October 16, 2024

**Re: Comments on the Final Recirculated Environmental Impact Report for Carbon TerraVault I**

In addition, we submit technical expert analyses prepared by Dominic DiGiulio, PhD (Attachment A); and Richard Kuprewicz (Attachment B). We refer the County to these reports, both here and throughout these comments, for further discussion of the Final REIR’s inadequacies.

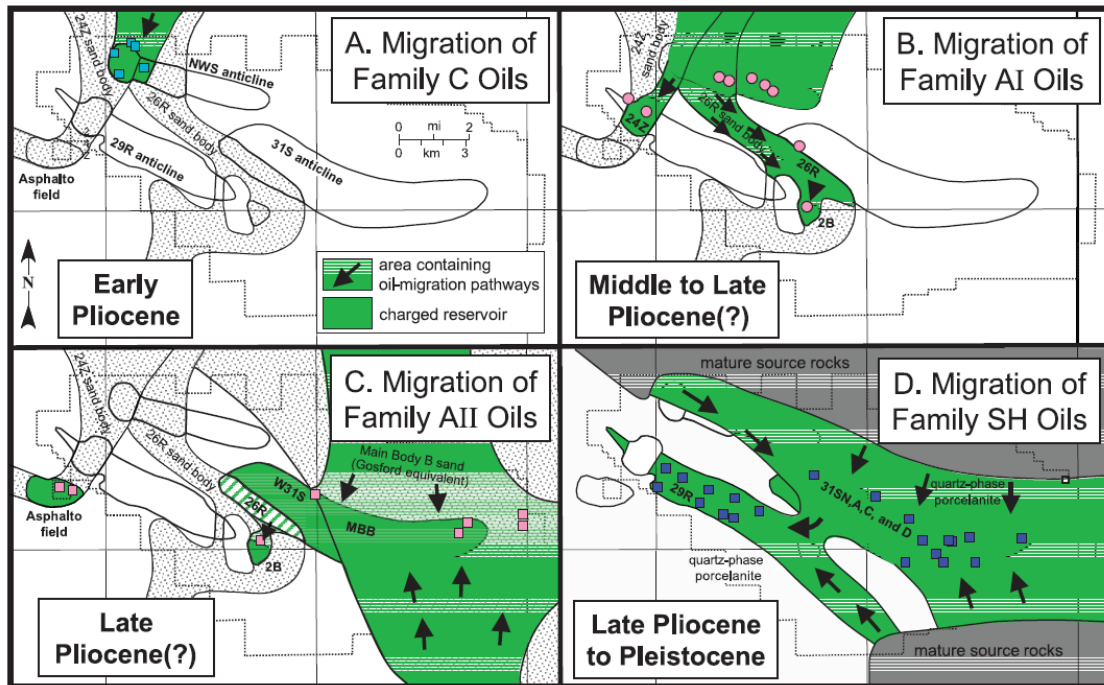
It appears then that there is hydraulic communication between the Monterey Formation inside and outside of the 26R and A1 - A2 reservoirs and injection must be carefully managed to avoid migration of injected CO<sub>2</sub> outside of these reservoirs (exceedance of spill point). From schematics provided by CTV, there are a large number of wellbores screened in the Monterey Formation outside of storage areas (Figure 2). At least some of these wellbores should be converted to monitoring wells to monitor for both pressure perturbation and CO<sub>2</sub> leakage during injection.

**Figure 3.** Simulation of 10% pressure loss per year, 0.1% pressure loss per year, and 0.01% pressure loss per year for 1000 years starting at 4000 psi.

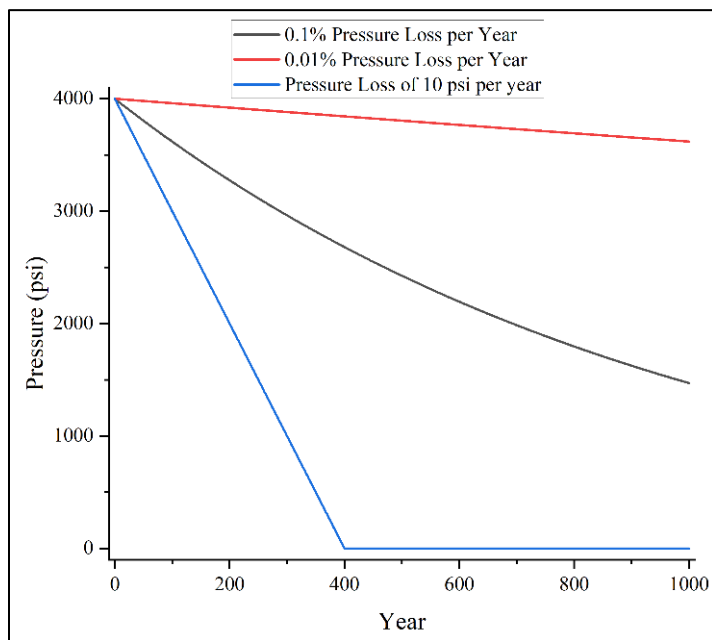
Comment on RDEIR on Pressure Loss of 10 psi per year: In Volume II of the recirculated DEIR (RDEIR, 2024b), CTV stated that computational modeling results calibrated with monitoring data (e.g., pressure) will be used to support that the plume has stabilized and that the pressure change is negligible (less than 10 psi per year) and poses no risk for potential vertical migration after cessation of injection in the A1 - A2 reservoir.

A pressure loss of 10 psi per year is not negligible. A simple back of the envelope calculation indicates that a pressure loss of 10 psi per year starting at 4000 psi (final target pressure) results in complete pressure loss in 400 years (Figure 3) resulting in appreciable CO<sub>2</sub> loss. In reality, the rate of pressure loss will decrease somewhat as pressure decreases in the formation (i.e., reduction in driving force) as illustrated in loss in percent per year (Figure 3). This metric of leakage verification is not sufficiently protective and should be rejected. A target of 0.01% pressure loss per year is more reasonable if permanent storage of CO<sub>2</sub> is actually the goal of this project.

County Response to Comment: In the Cornerstone Engineering Report (2024), Cornerstone Engineering states the following:

“The comment asserted that ‘a pressure loss of 10 psi per year is not negligible’. The comment is inapposite to the true context of the quoted reference from the RDEIR... ‘Figure 1 [Figure 4 here] from the Post-Injection Site Care and Site Closure Plan (included below) depicts modeled reservoir pressure during the injection period (years 1-25) as well as post-injection period (years 26-120). As shown in Figure 1 [Figure 4 here] below and included in the EPA Class VI Permit, in the early years post-injection (years 26-35), pressures stabilize such that a pressure change of up to 10 psi per year may (and is expressly modeled) to occur. However, in later years, as the pressures have stabilized, a pressure change of 10 psi per year is not forecasted. Measured pressures that deviate from the forecasted pressures included in Figure 1 [Figure 4 here] below would trigger a reassessment of the AoR and potentially the post injection site care period

extended as detailed in the EPA Class VI permit condition included above. Therefore, the project does not anticipate a 10-psi pressure change annually over the life of the project, nor would such a pressure change be permitted pursuant to the terms of the Class VI EPA Permit. Moreover, the commenter implies based on their ‘simple back of the envelope calculation’ that a pressure loss of 10 psi per year results in a decrease in pressure from 3250 psi (initial reservoir and final target pressure) to 2250 psi in 100 years resulting in appreciable CO<sub>2</sub> loss.’ First, as noted above, the commenter’s assertion of a pressure loss for 100 years contradicts the modeled pressure changes, and the commenter provides nothing more than bare speculation for the assertion that a pressure loss would continue for that time period. Moreover, the pressure change of 10 psi per year does not indicate a loss of CO<sub>2</sub> to the atmosphere. Rather, this indicates the forecasted settling of CO<sub>2</sub> within the pore space of the reservoir and does not indicate a ‘loss’ of CO<sub>2</sub> as the commenter incorrectly states...

**Figure 4.** Simulated pressure and cumulative mass injection at 26R reservoir. Figure from Volume II of RDEIR. The poor resolution of this figure is due to poor resolution in Volume II of the RDEIR.

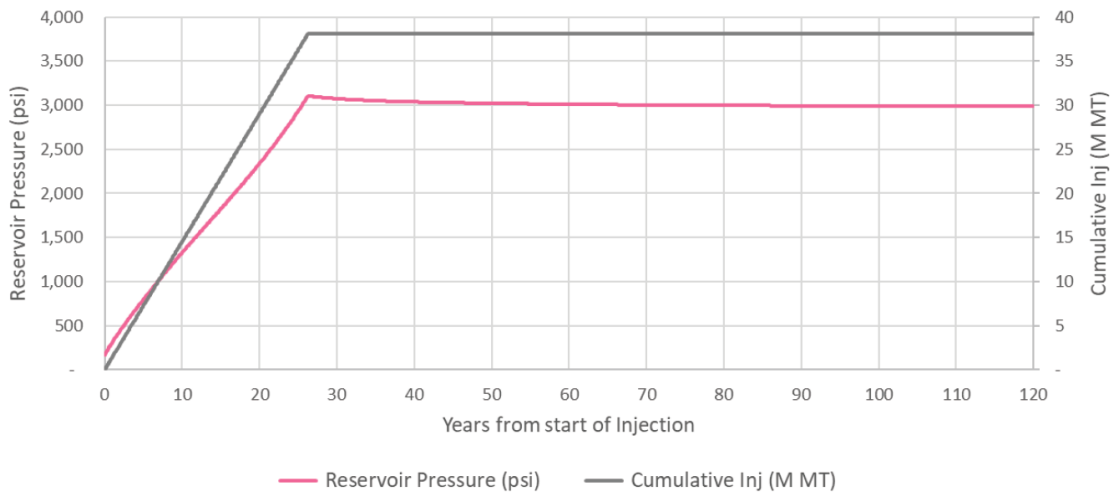
The commenter goes on to suggest that a target of 0.01% pressure loss per year would be more reasonable. We disagree. That very low value is both inconsistent with the reservoir simulation results and outside of the practical measured accuracy within a geologic system. Computational modeling results calibrated with monitoring data (e.g., pressure) will be used to support that the plume has stabilized, that the pressure change is consistent with the model (included in Figure 1 above and in the EPA Class VI permit), and that no risk for potential vertical migration exists.”

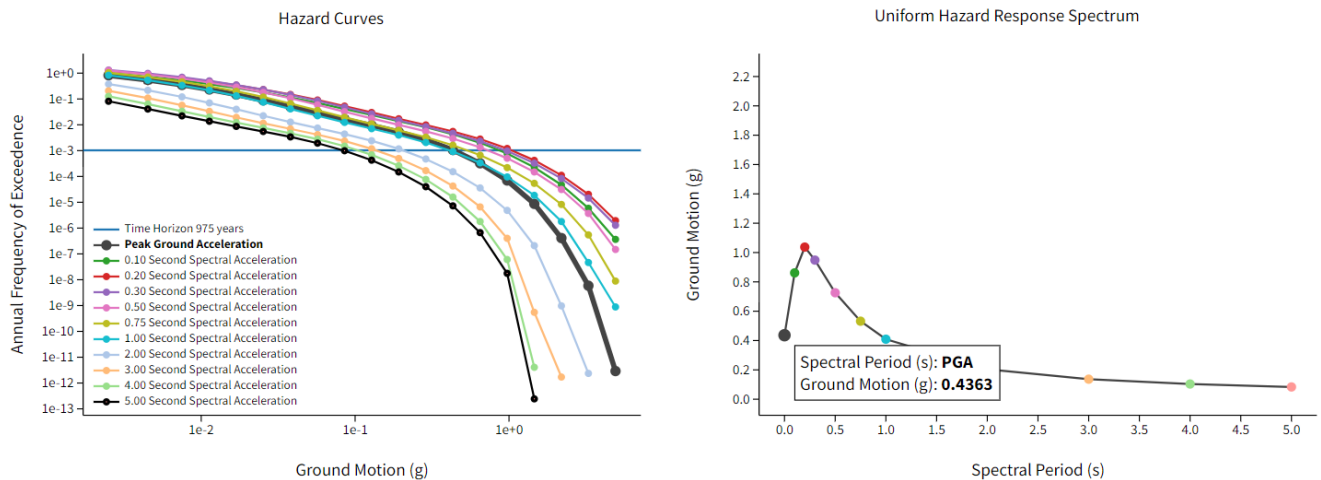
For the project location, a peak ground acceleration rate of 0.4363g was estimated having a 5% probability of exceedance in 50 years with an annual rate of exceedance = 1.025E-03 or a return period of 475 years (RDEIR, 2024b). The return period or time horizon is the inverse of the annual rate of

exceedance. Using the USGS “rule of thumb” for calculating return period, this is approximately equivalent to a 9.8% probability of exceedance in 100 years, a 42% probability of exceedance in 500 years, and a 69% probability of exceedance in 900 years.

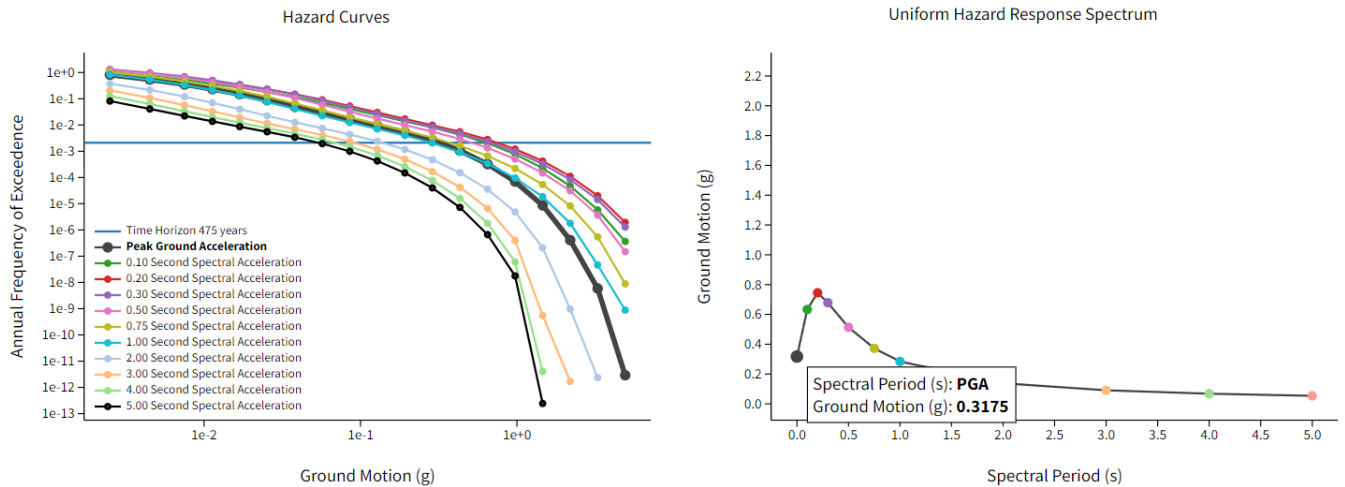
A further examination of the hazard curves (Figure 8) (performed here) indicates a peak ground acceleration of 0.3175g having a 10% probability of exceedance in 50 years, 19% probability in 100 years and a 64% probability of exceedance in 400 years. Care was taken in these calculations to ensure that  $r^* \leq 1$  where  $r^* = r(1+0.5r)$  and  $r$  = probability as recommended by USGS (USGS, 2024).

**Figure 9.** Schematic representation of pressure migration along a high-permeability fault between the Tejon Oil Field and a M 4.6 seismic event along the White Wolf Fault.

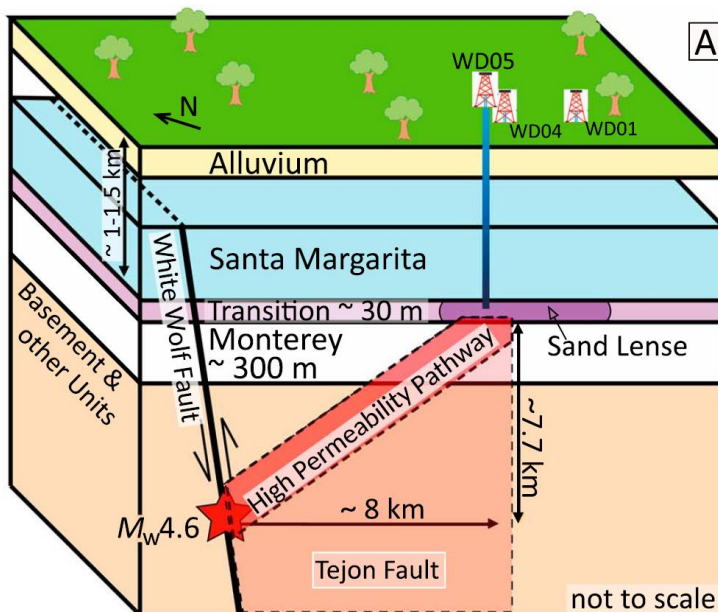
Based on geological mapping, seismicity, and well-log data, Goebel et al. (2016) identified a seismically active normal fault referred to as “Tejon Fault” in proximity to the Tejon Oil Field which deepened (7.7 km) toward the northwest below the Wheeler Ridge fault before intersecting with the White Wolf Fault 8 km from injection wells (Figure 9).

intersecting with the White Wolf Fault 8 km from injection wells (Figure 9). Pressure diffusion was likely influenced by an 11 km high permeability pathway along the seismically active part of the Tejon fault (Goebel et al., 2016). Numerical modeling indicated that for a fault zone permeability above ~300 mD and fault width below ~800 m, a pressure increase of just 0.01 MPa (1.5 psi) was sufficient to induce seismicity on a fault favorably oriented to slip (Goebel et al., 2016).
